RINGMORE.

Ringmore Church Bells

Report on the Tower & Bells of Holy Trinity, Ringmore

Chinning frame

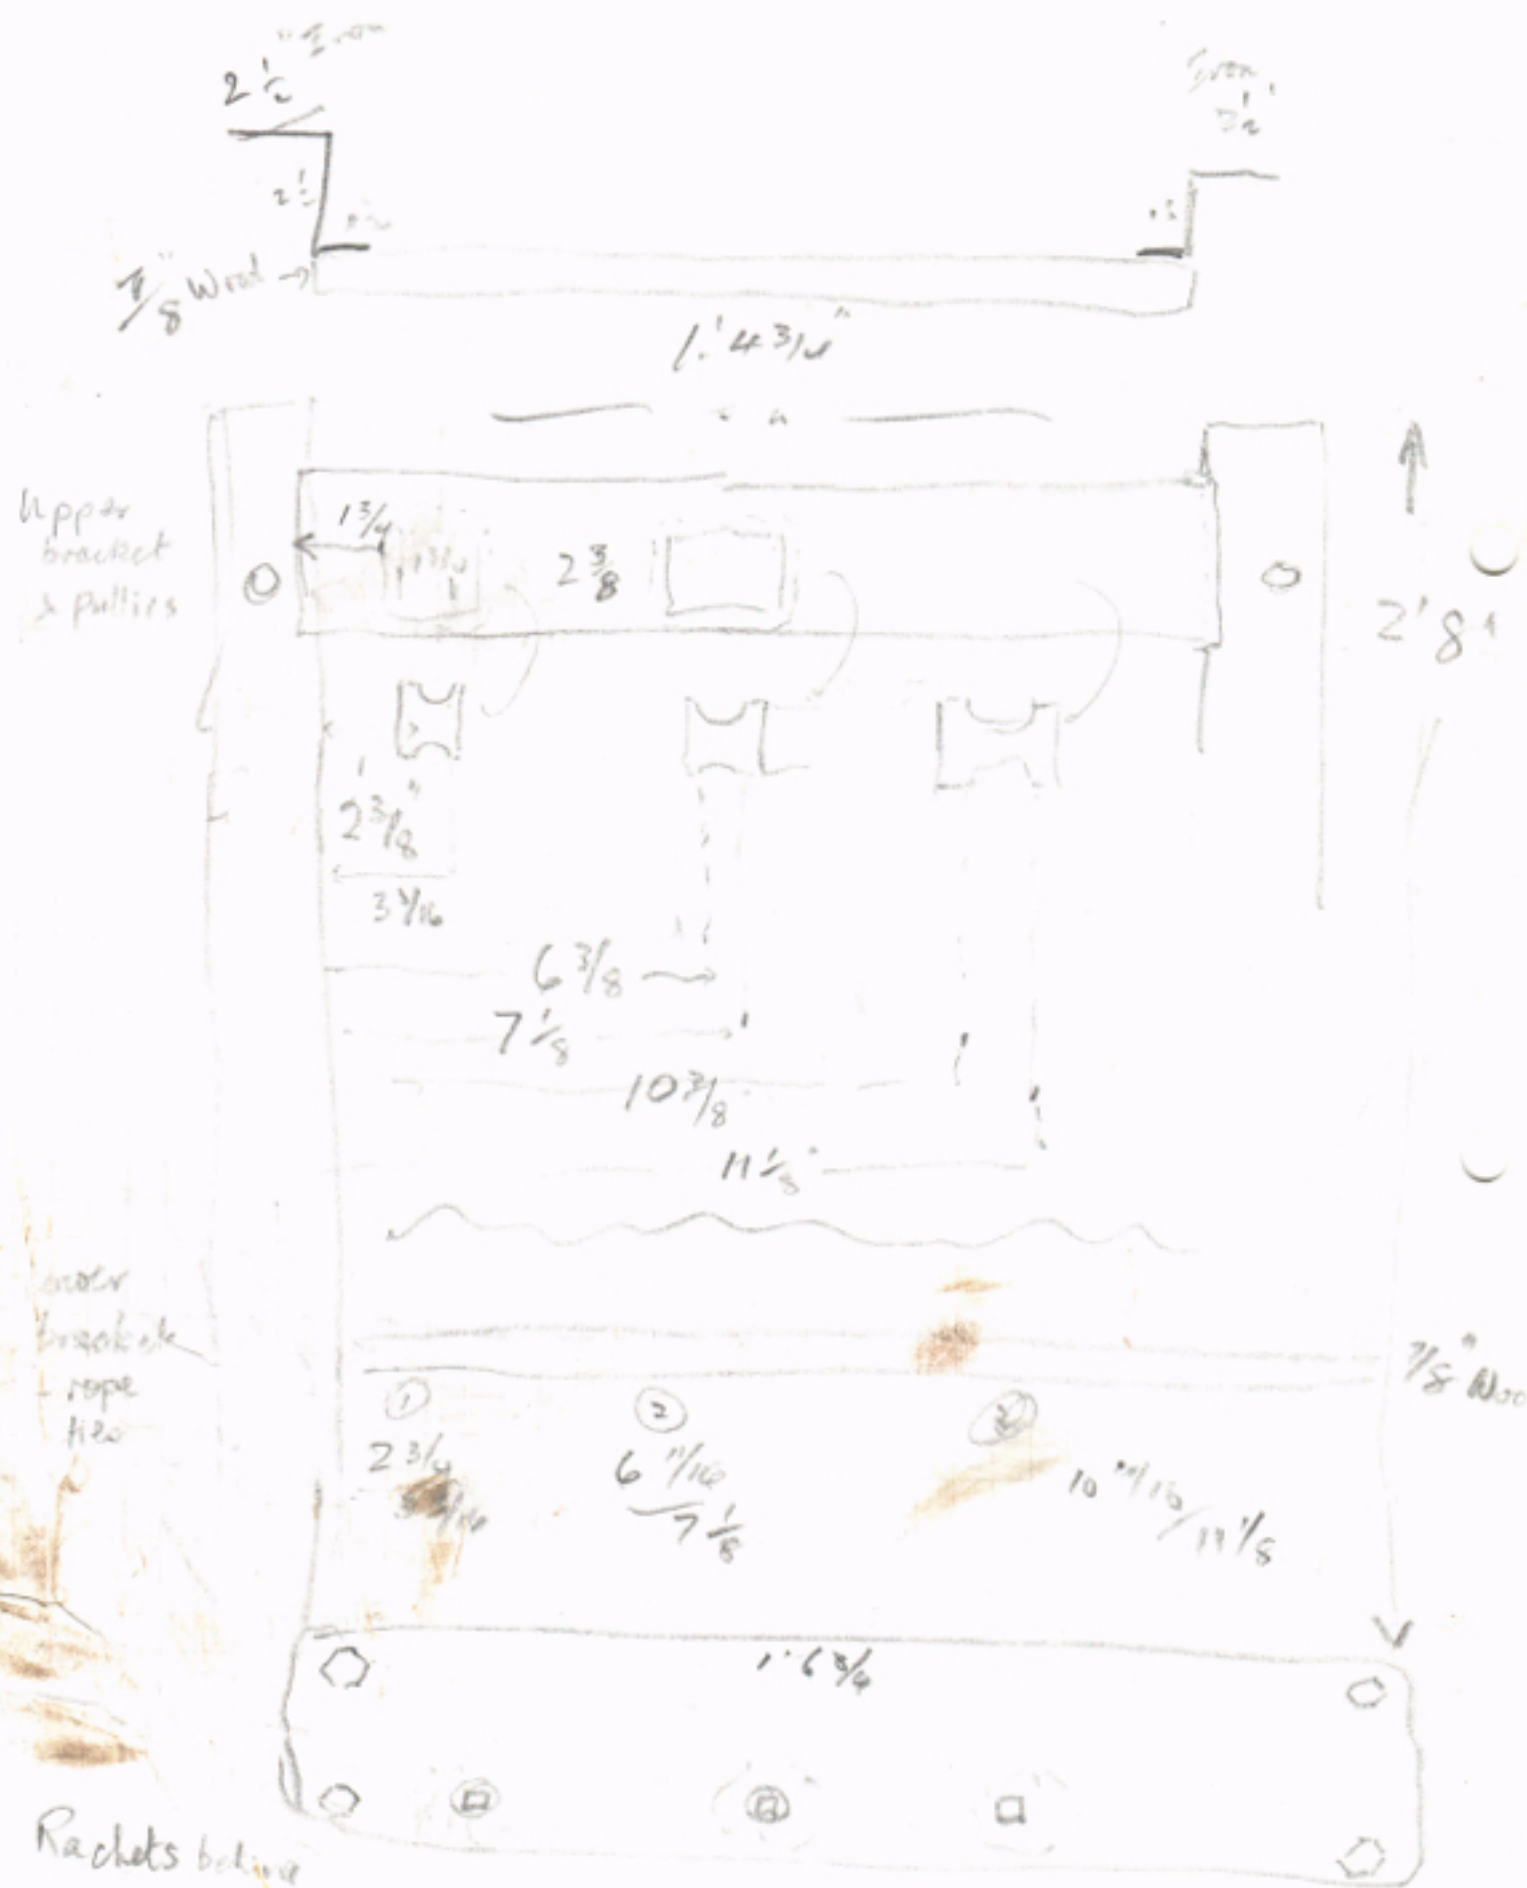
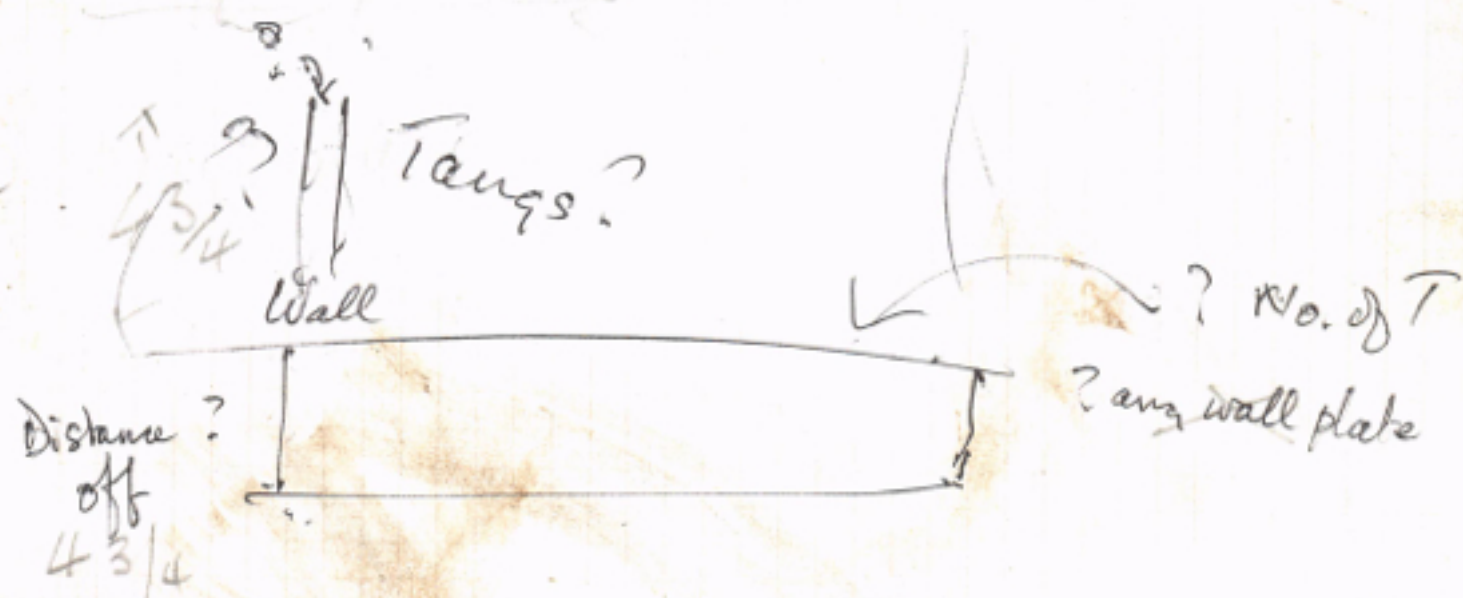
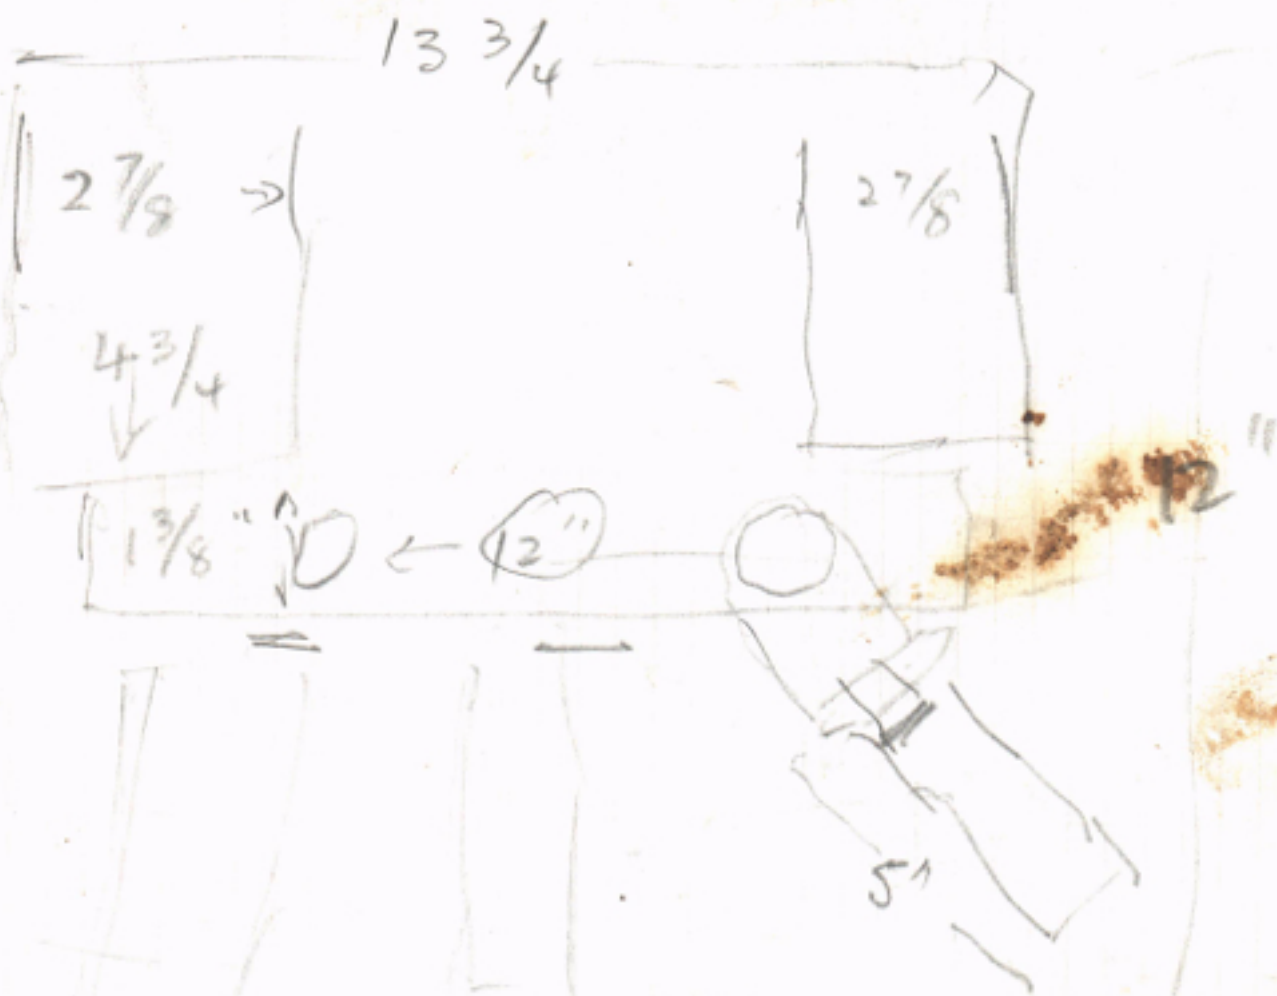
One of the holdfasts at the top of the ladder is rusting badly and should be replaced: it would be highly dangerous were the ladder to come off the wall when someone was on it, and a second pair of holdfasts would be a wise precaution.

*Hold fast position? size?
(inside room)*

3. The bell fastenings should be checked over, and any suspect nuts replaced in stainless steel; the rest should be painted in the same way as the frame.
4. The doorway to the tower roof needs to be fitted with doors which fit round the flue-pipe and exclude birds and as much weather as possible. The sound openings in the belfry should have any missing louvres replaced and should be fitted with "Weldmesh" bird-guards; these could be of a size big enough to allow the bats to pass through but exclude jackdaws and pigeons -- say 2".
5. The rusty holdfast at the top of the belfry ladder should be replaced, and a second pair of holdfasts fitted about 6 feet below, as a safety precaution.
